CHANGE ORDER NO. 1

October 29, 2018

Subject: Murdock Elementary School Relocatables
Willows Unified School District
Architect's Project No.: 2017-1317

Reference:
Dwg./Document No.: C3.1 Rev.: _____ Title: Utility Plan

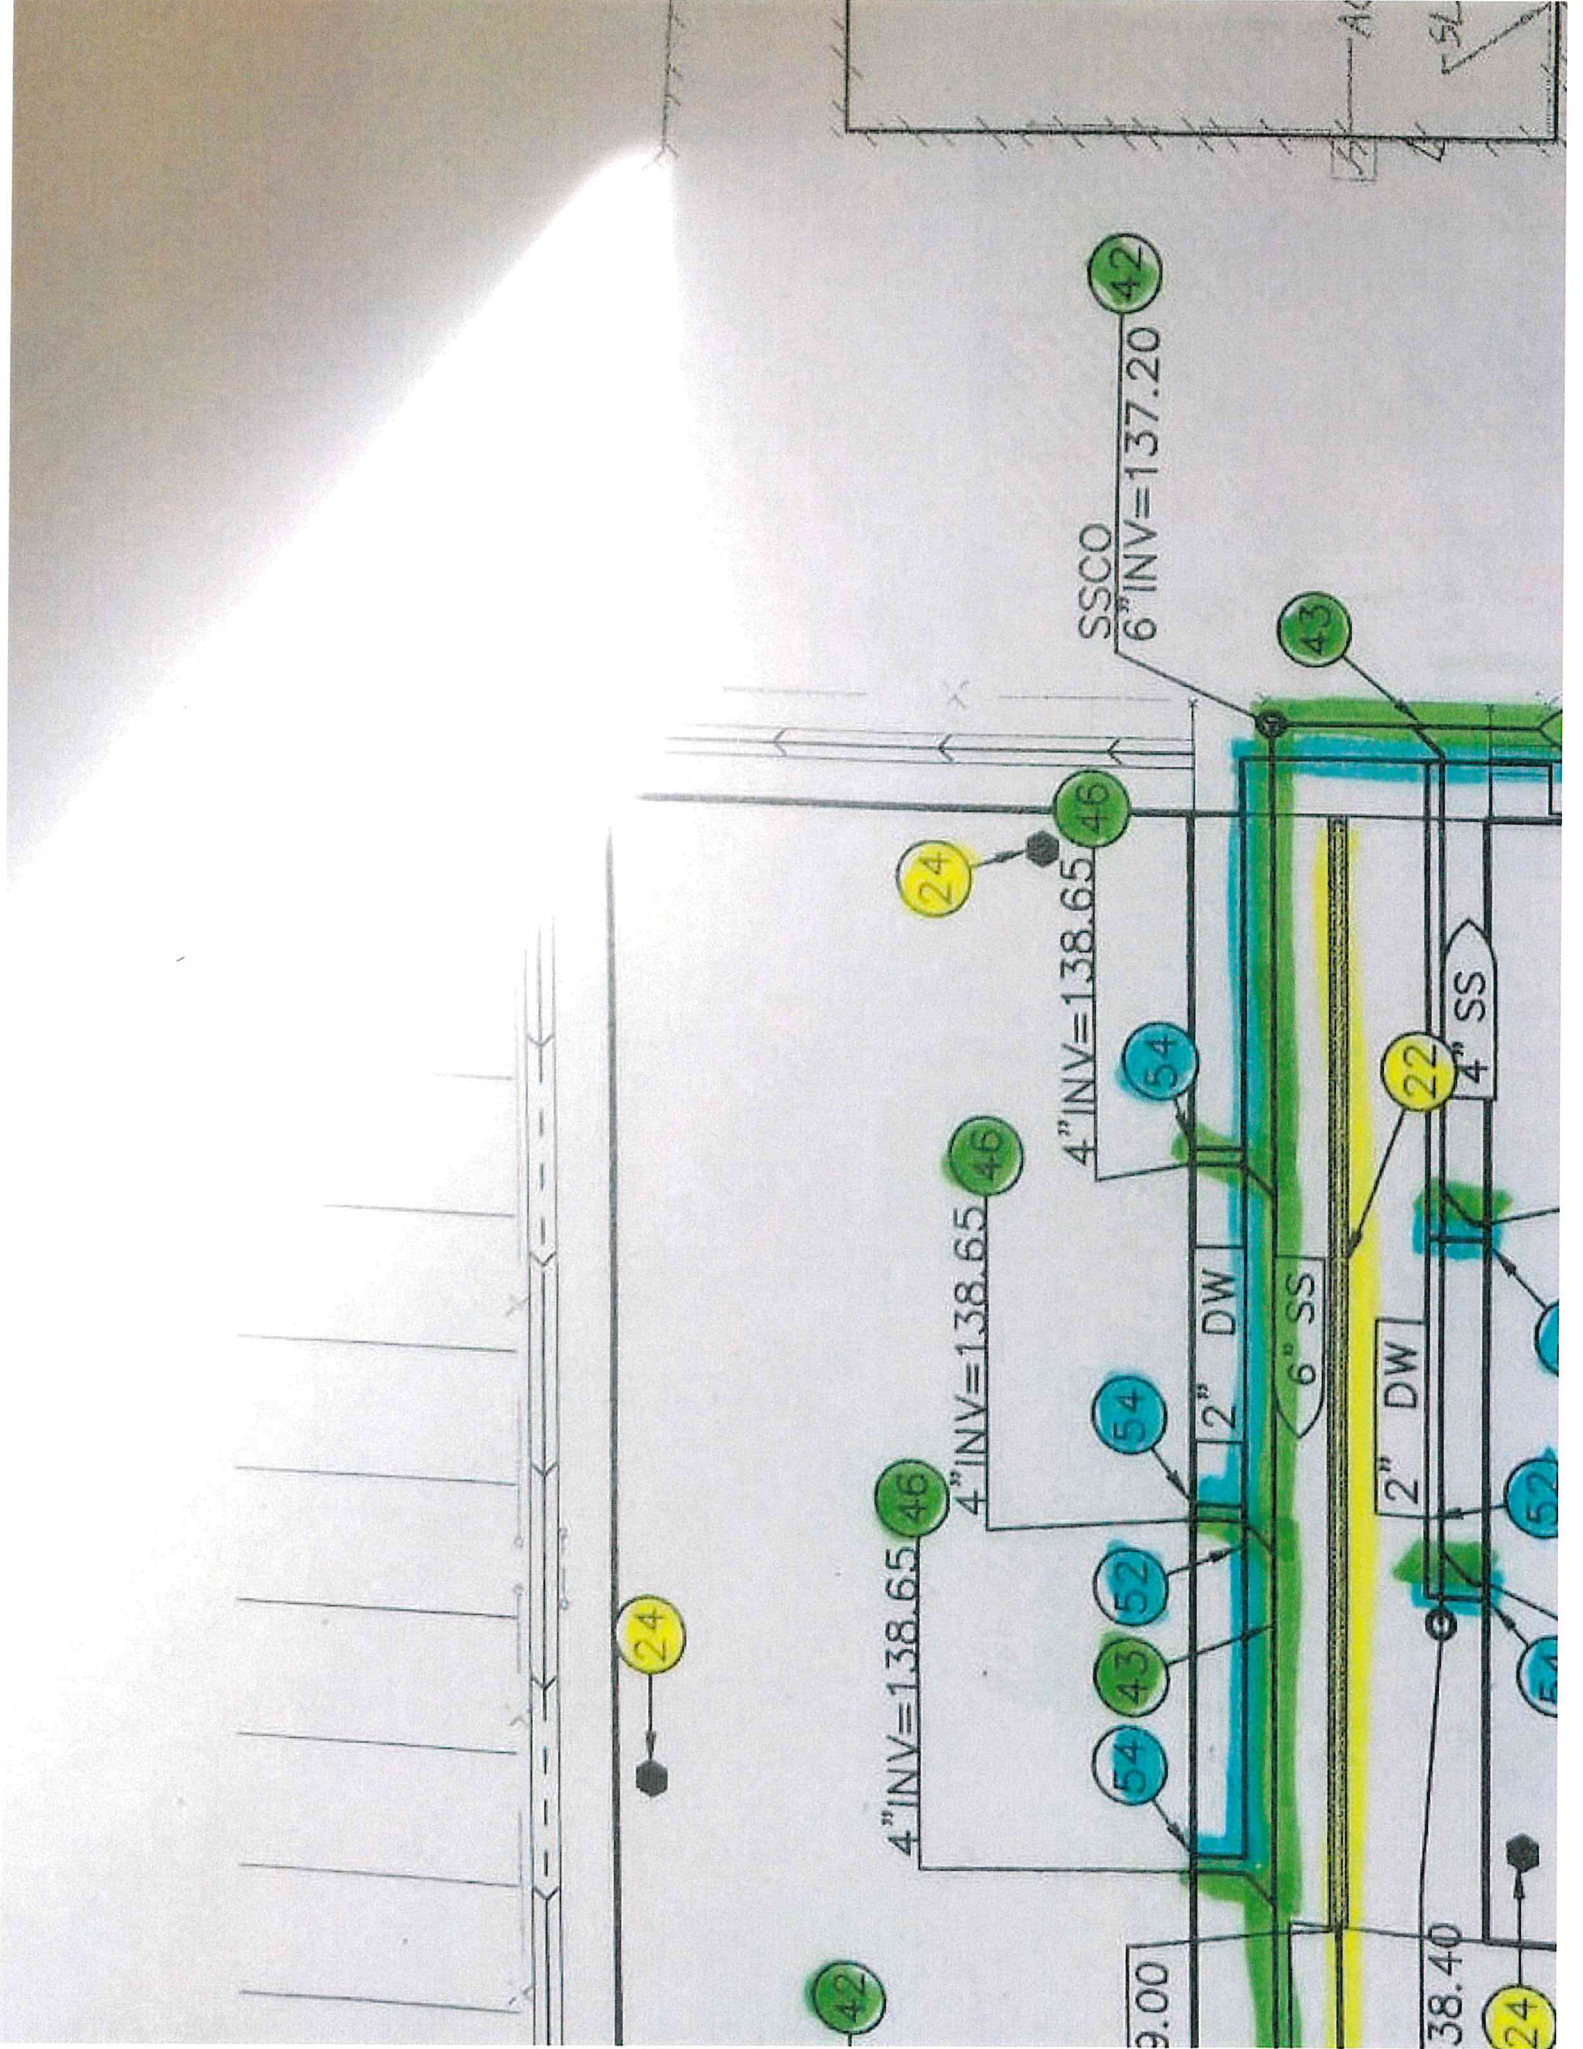
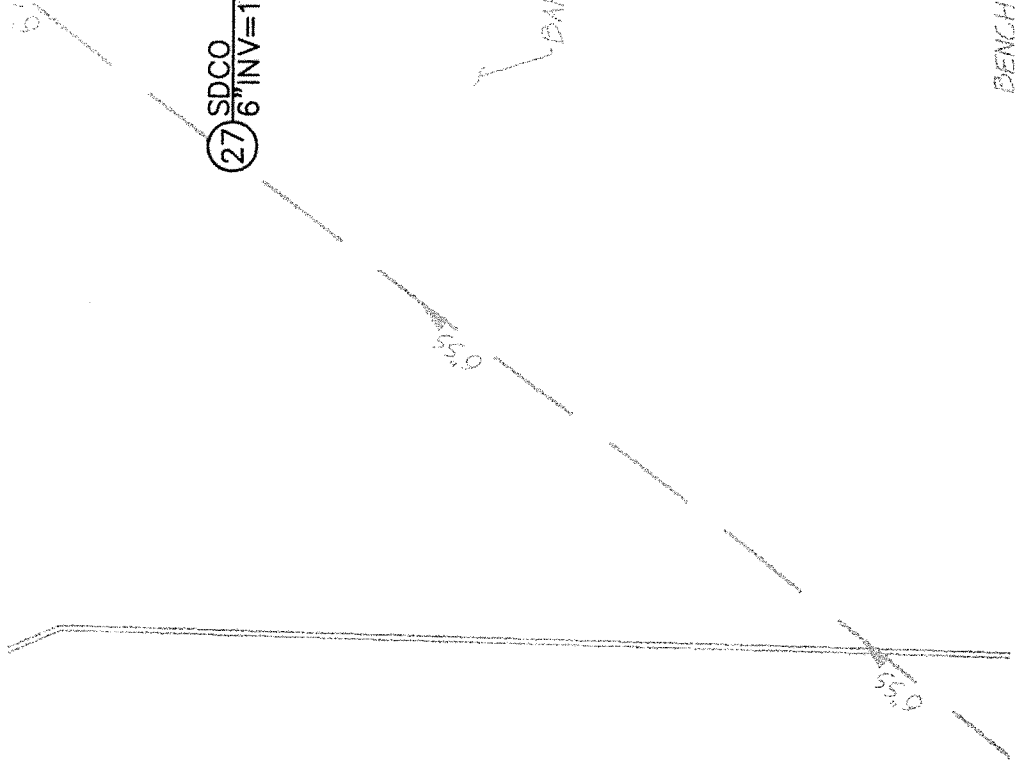
Is it possible to make the domestic water connection to the existing buildings adjacent to the new portables opposed to the location depicted in the plans. See attached photos and drawings. There would be a cost savings for a reduction in LF of trench (TBD). The existing line located 6/1 appears to be a 2.5" or 3" service.

Confirmed pipe size and that it is connected to the domestic water service. If pipe size is 2.5" or greater and is a domestic water line, it is acceptable.

Reference: _____
Dwg./Document No.: L2.1 Rev.: _____ Title: Landscape and Irrigation Plan

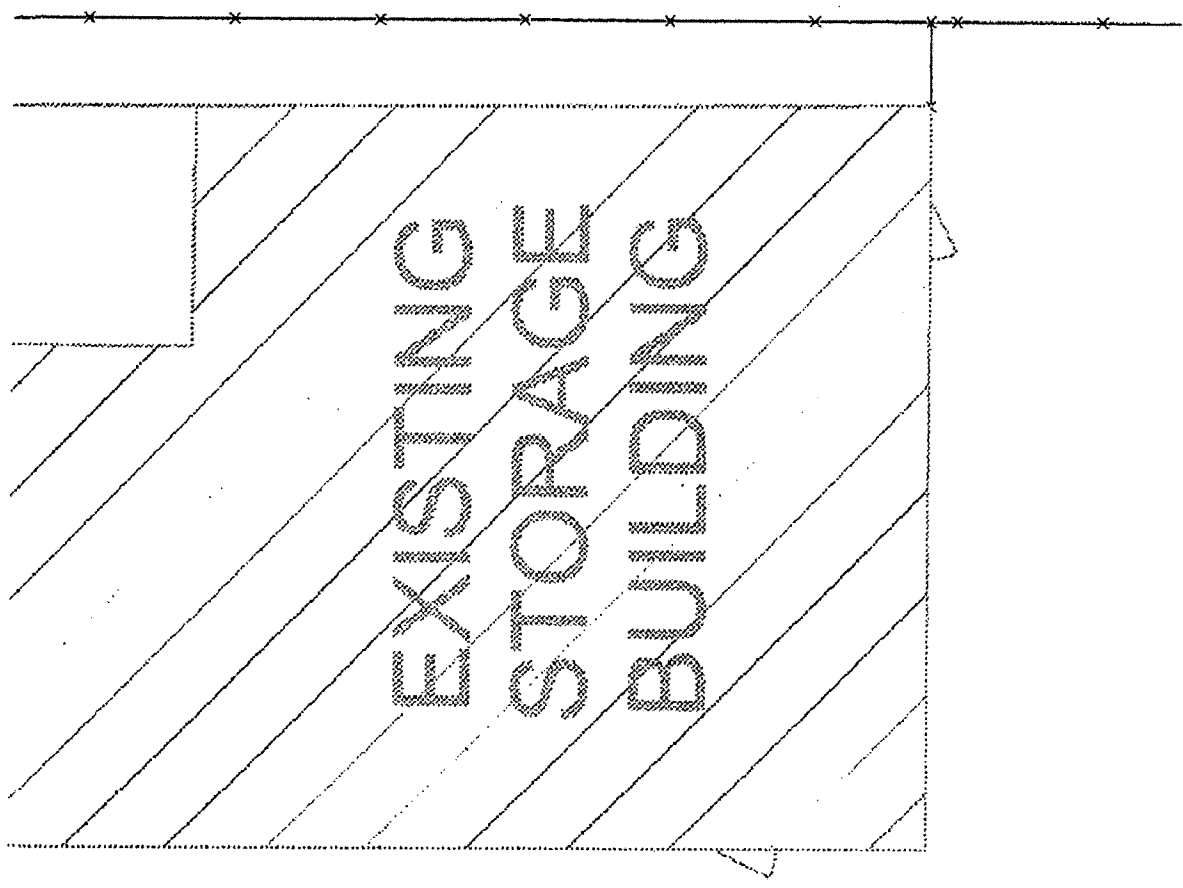
This RFI is to confirm per discussion with WUSD to eliminate the trees, tree wells and associated irrigation in the pavement area west of unit P3. WUSD has requested 4 total trees to be planted near the new basketball courts at a location identified by WUSD. Per WUSD an existing, but unused, irrigation line is available to tie into, if necessary, to install tree bubblers. The tree well areas would be paved back with the rest of that AC section.

Confirmed. Provide itemized costs and deduction for architect and owners review.
Jeff Juarez
RGA

PAVING PLAN	C4.1	DATE: 06/5/18
MURDOCK ELEMENTARY SCHOOL		PROJECT NO. 2017-1317
WILLOWS UNIFIED SCHOOL DISTRICT		SHEET
WILLOWS, CA		CCD002-C4.1A

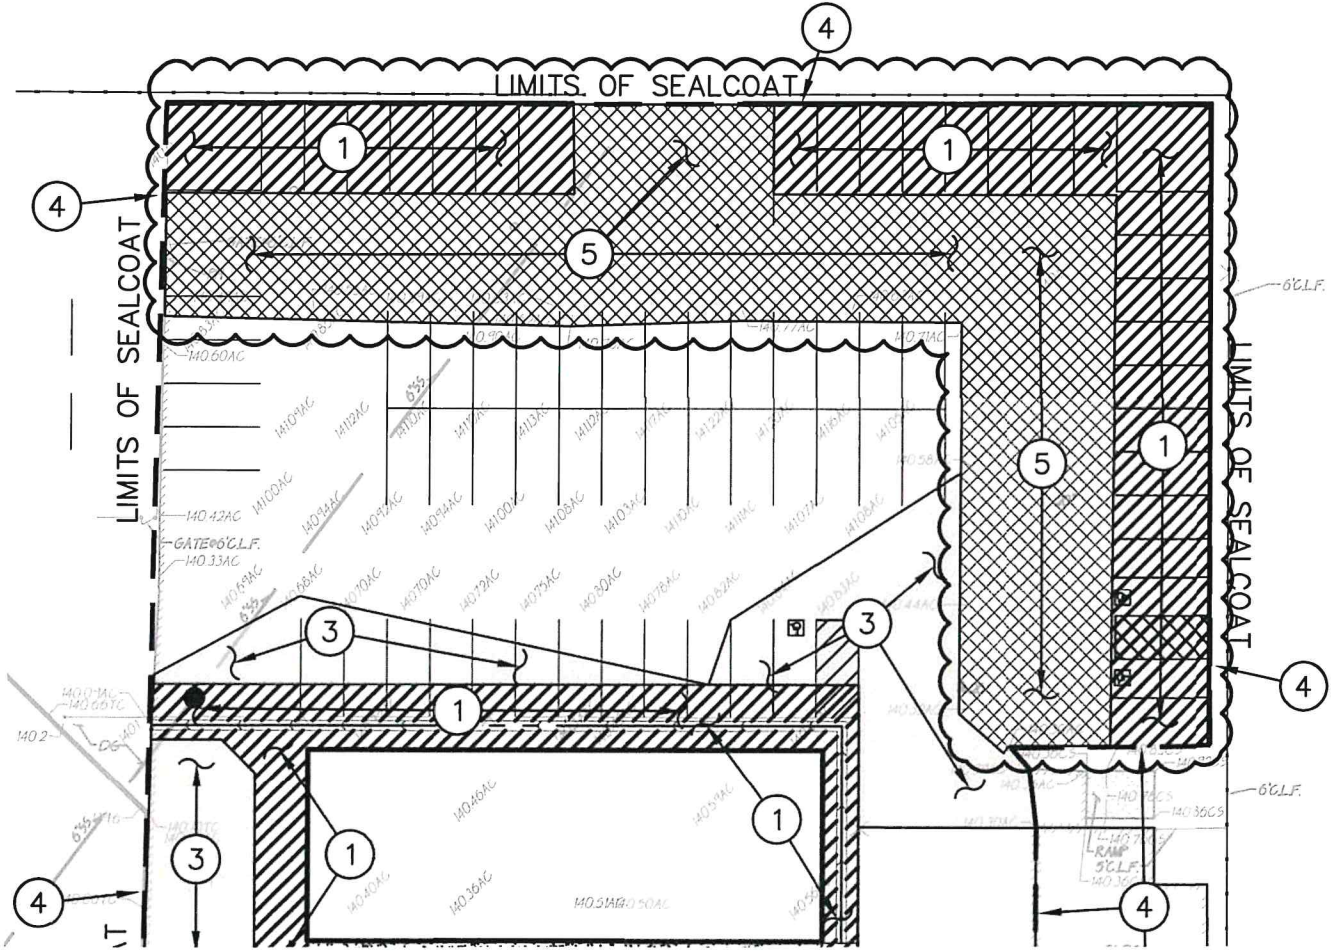
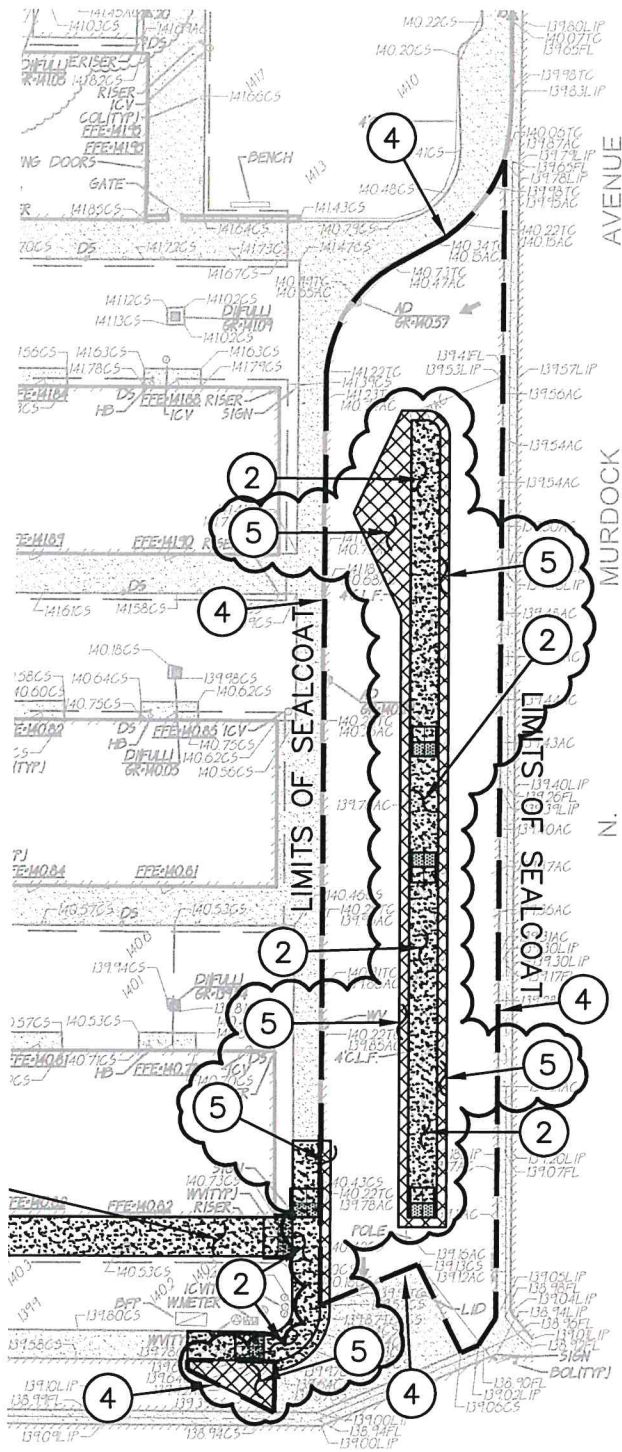
The paving section, Type 1, as noted on sheet C4.1 is incorrect. The attached sheets, CCD 002- C4.1A and CCD 002-C4.1B provide the correct paving section.

Please provide itemized change in credit as required by the Contract Documents for Owner and Architect review.
